ATTACHMENT 6

Dresden Station Unit 2

DPR-19

Proposed Technical Specifications

Figure 3.5-2 (Sheet 1 of 2) MPR Limit for Reduced Core Flow

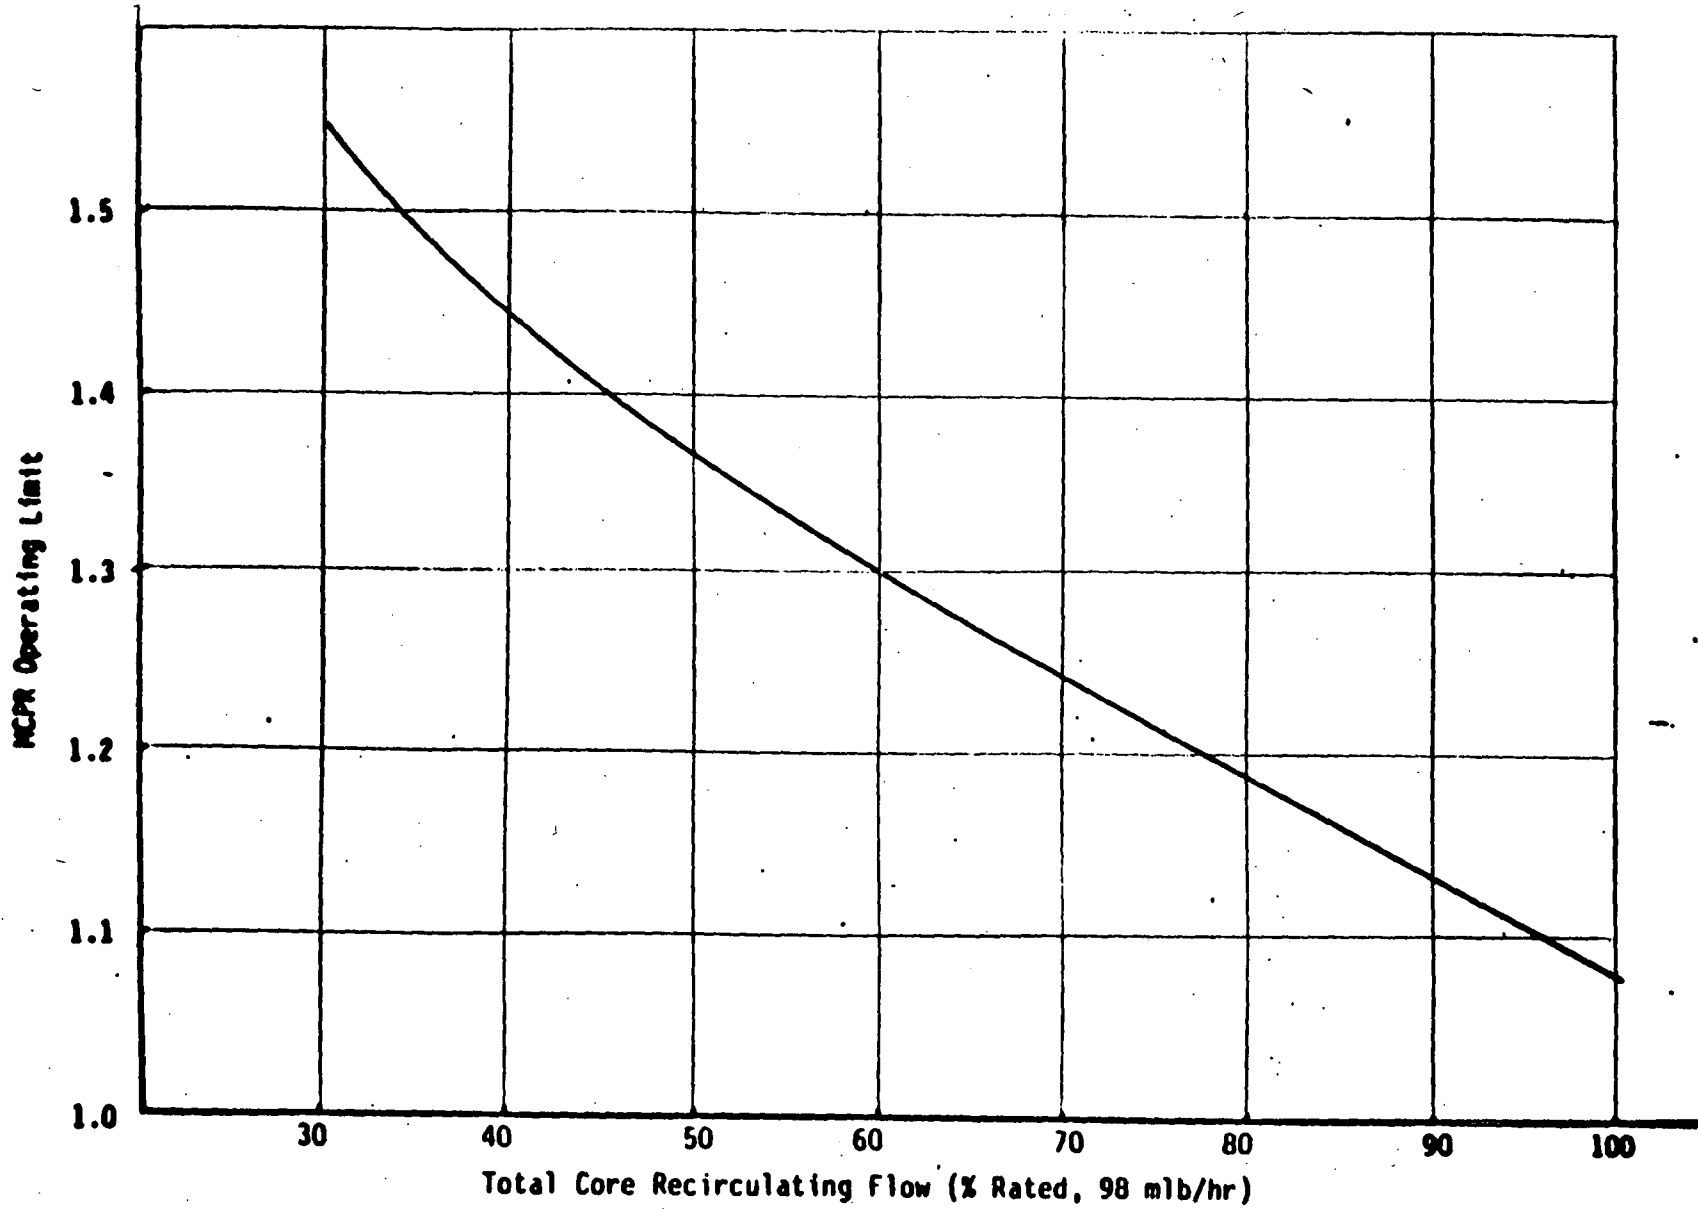
1. Manual Flow Control-the MCPR Operating Limit shall be the value from Figure 3.5-2 sheet 1 or the above rated core flow value, whichever is greater.
2. Automatic Flow Control-the MCPR Operating Limit shall be the value from Figure 3.5-2 Sheet 1, Sheet 2 or the above rated core flow value, whichever is greatest.

Figure 3.5-2 (Sheet 2 of 2) MCPR Limit for Automatic Flow Control

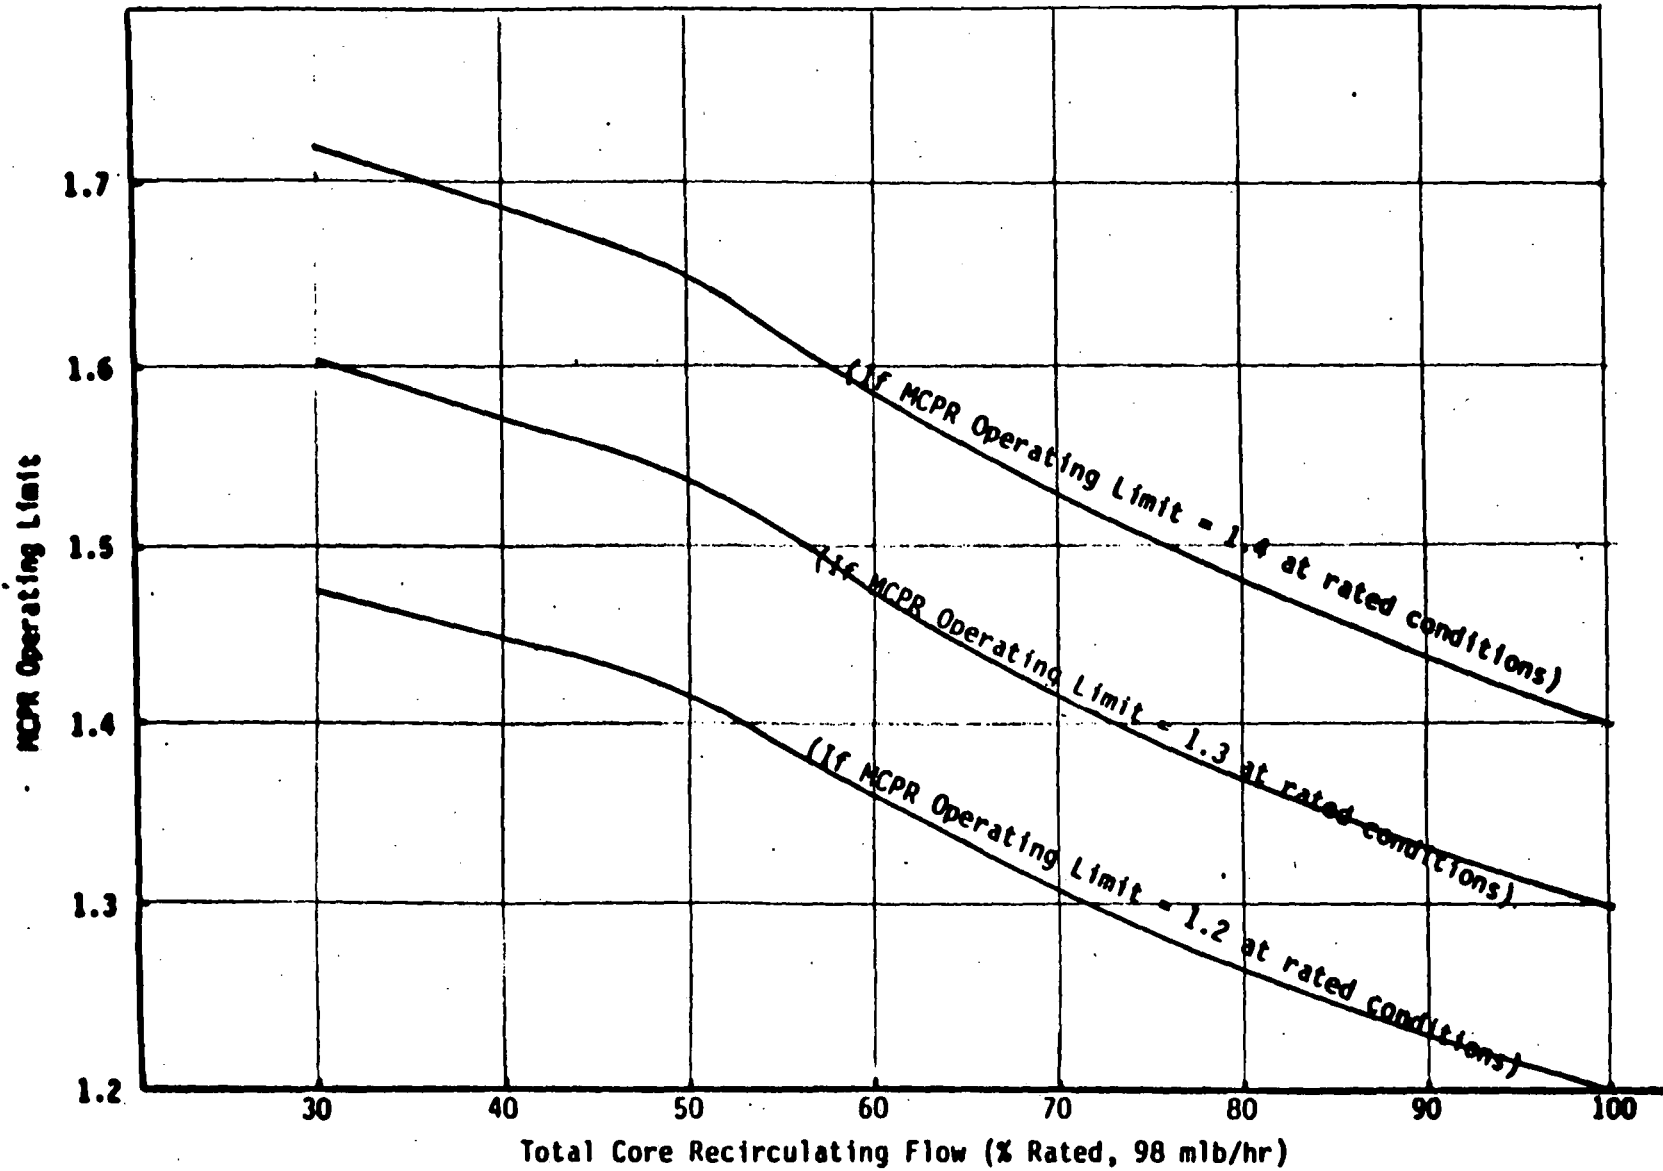
Therefore, for Automatic Flow Control, the MCPR Operating Limit is chosen as the value from Figure 3.5-2 Sheet 1, Sheet 2 or the rated flow value, whichever is greatest. It should be noted that if the rated flow MCPR Limit must be increased due to degradation of control rod scram times during the current cycle, the new value of the rated flow MCPR limit is applied when using Figure 3.5-2 Sheet 2.
